UNITED STATES PATENT AND TRADEMARK OFFICE

Office Action Summary

10/812,945

DETAILED ACTION

In this regard DE0010037813 shows the following:

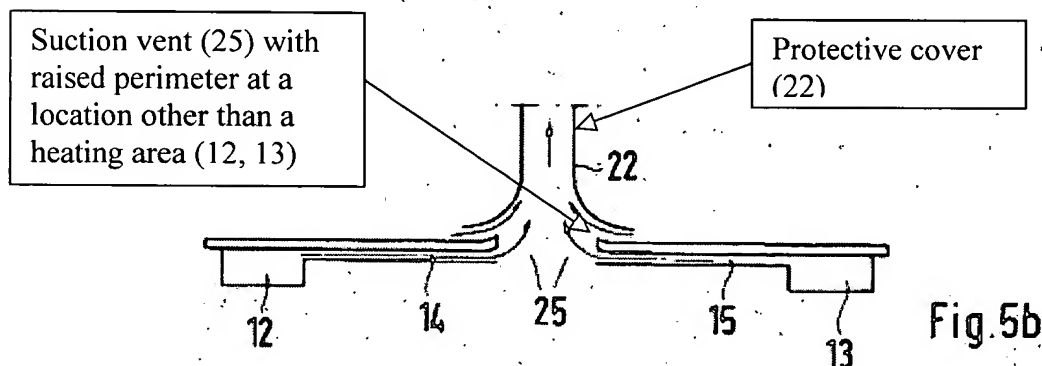
DE0010037813 shows and disclose (See the English language abstract) a glass-ceramic stove top plate (1) comprising at least one opening (25) located within a bent portion of said plate, said opening being at a location other than a heating area and having an outer peripheral edge thereof bent upwards, and wherein said opening is a suction hood opening configured for use with a suction hood for allowing for the extraction of cooking gases. The central opening has a protective cover which, at least to some degree, prevents objects passing into the opening during operation.

DE0010037813 shows and discloses the invention substantially as set forth in the claims with possible exception to:

- one opening having an angular or polygon shape.

In this regard **JP60-144530** shows the following:

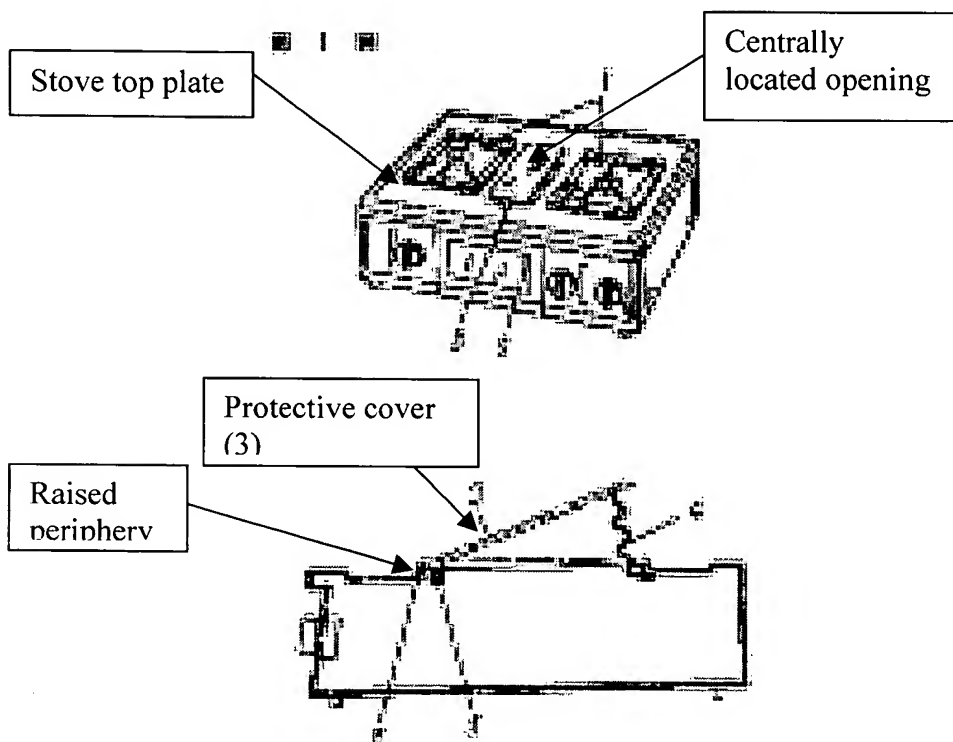
JP60-144530 shows and disclose (See the English language abstract) a stove top plate (1) comprising at least one opening (6) located within a bent portion of said plate, said opening being at a location other than a heating area (1) and having an angular or polygon shape with an outer peripheral edge thereof bent upwards. The central opening has a protective cover which, at least to some degree, prevents objects passing into the opening during operation.
